August 2, 2010

MEMO TO: Agricultural Advisory Board

SUBJECT: **USE PERMIT APPLICATION NO. 2010-09 & LOT LINE ADJUSTMENT APPLICATION NO. 2010-10 - SCATEC WESTSIDE SOLAR RANCH - ALTERNATIVE AGRICULTURAL BUFFER AND SETBACKS**

Re: Scatec Westside Solar Ranch, Stanislaus County, CA
Use Permit No. 2010-09 and Lot Line Adjustment Application No. 2010-10

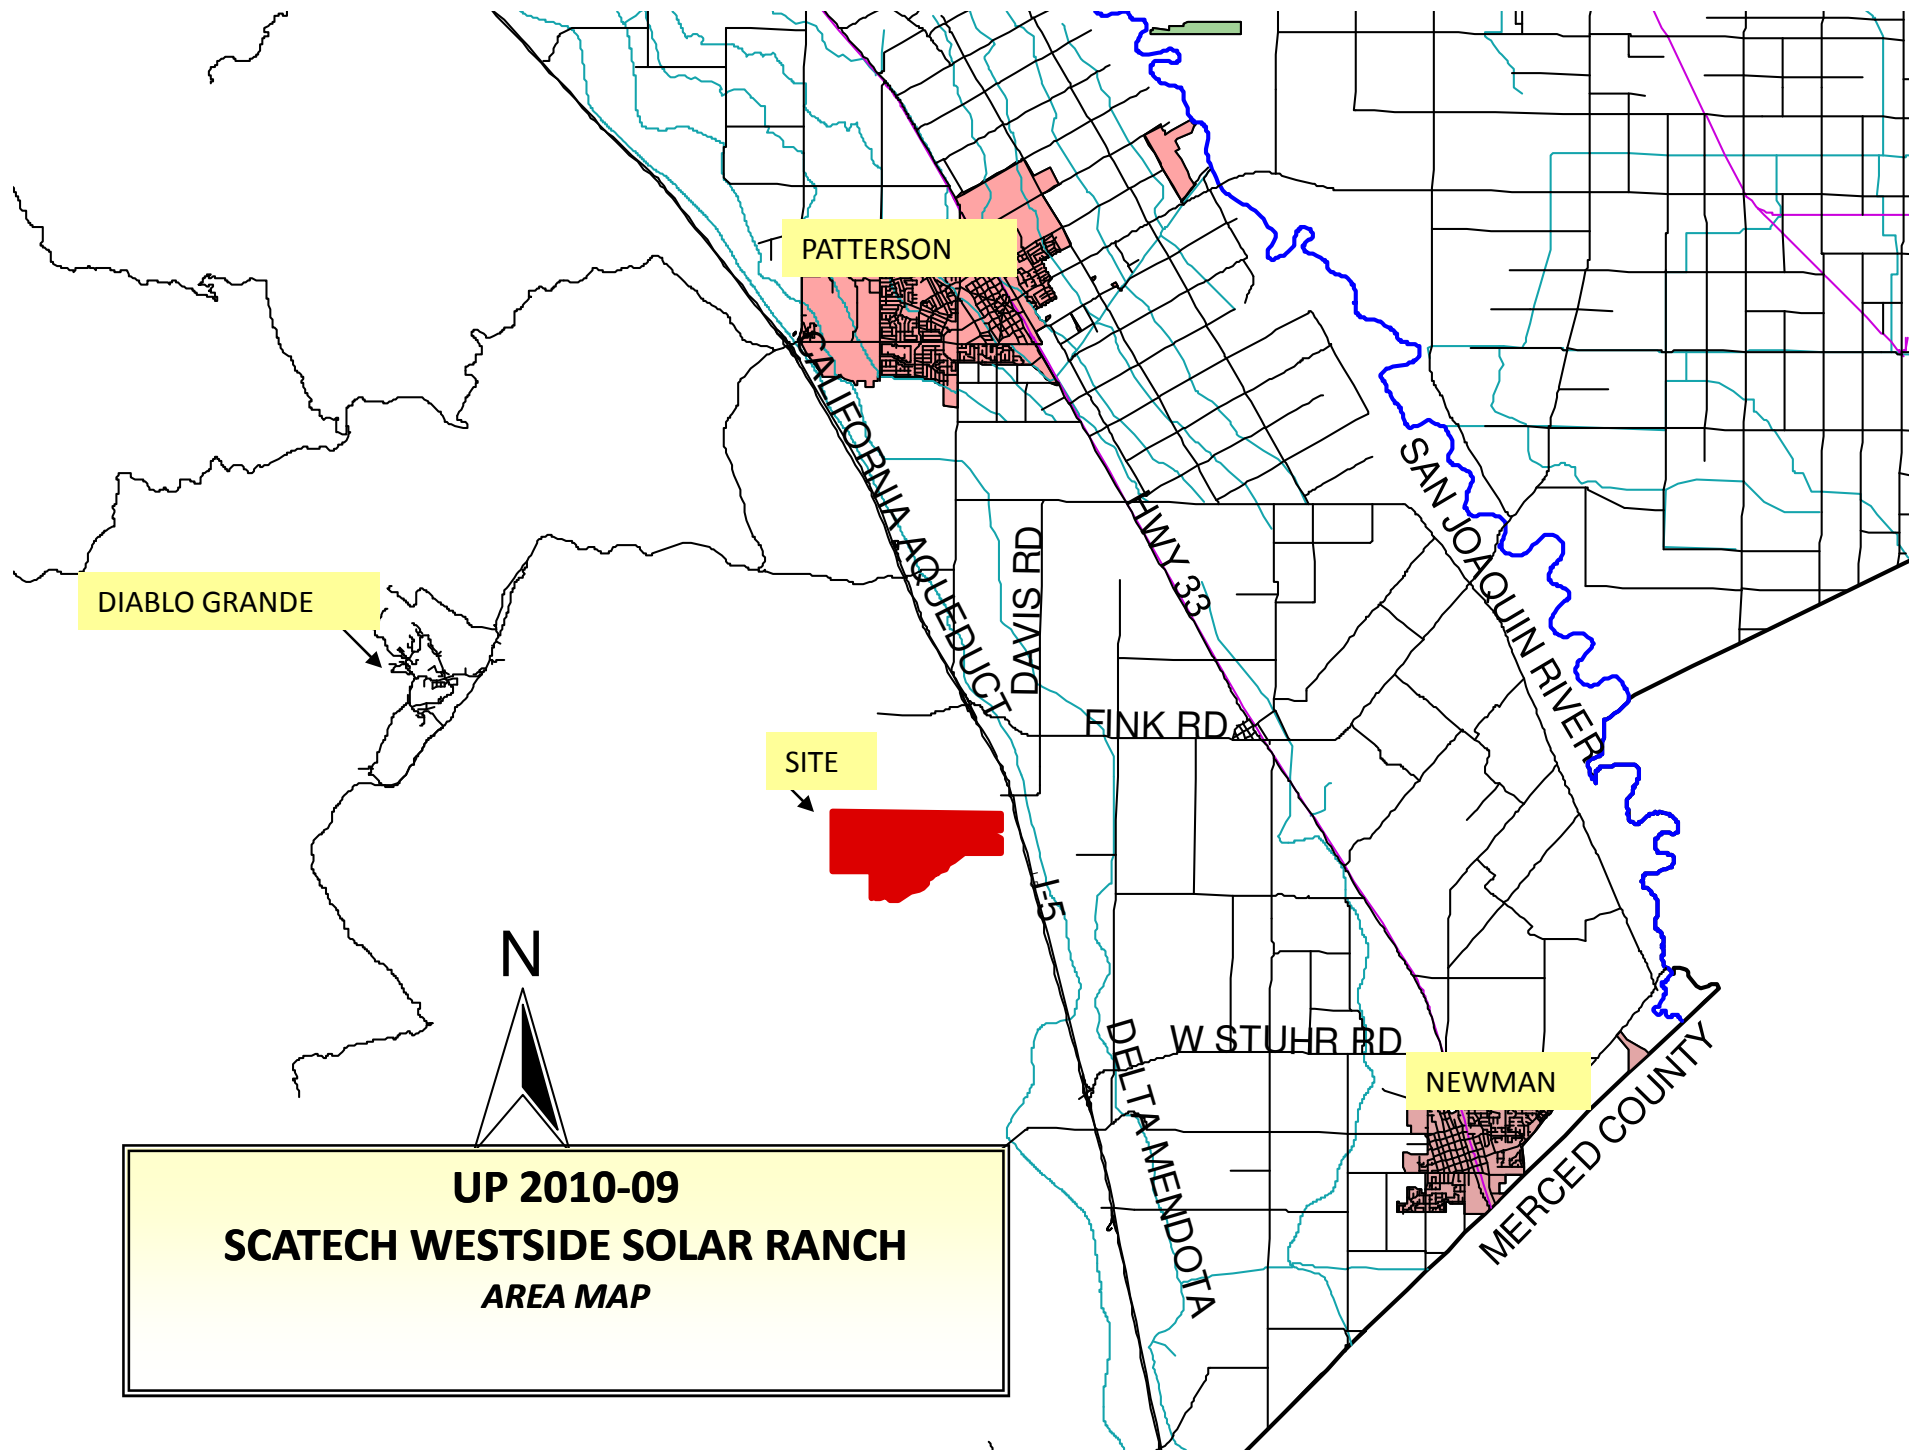
This letter is being provided to the County to request an Agricultural Buffer Alternative for the Scatec Westside Solar Ranch project located west of I-5 and southwest of the Fink Road Landfill. We have attached an exhibit that depicts the proposed setbacks and adjacent land uses for your reference.

The applicant would like to propose an alternative buffer consisting of 20 foot from property line to edge of solar panel on the West and South property lines and a 150 foot buffer on the north and east property lines. No vegetative screening is being proposed. Fencing will consist of a 6 foot high cyclone fence for security purposes.

The 20-foot setback on the west and south boundaries includes a 20 foot wide perimeter access roadway. The 150-foot setback on the north property line consists of an existing 30 foot access road that will remain (the 30-feet lies between the Beltran Farm north property line and the proposed project north property line) and 120-feet from the project north property line to the nearest solar panel.
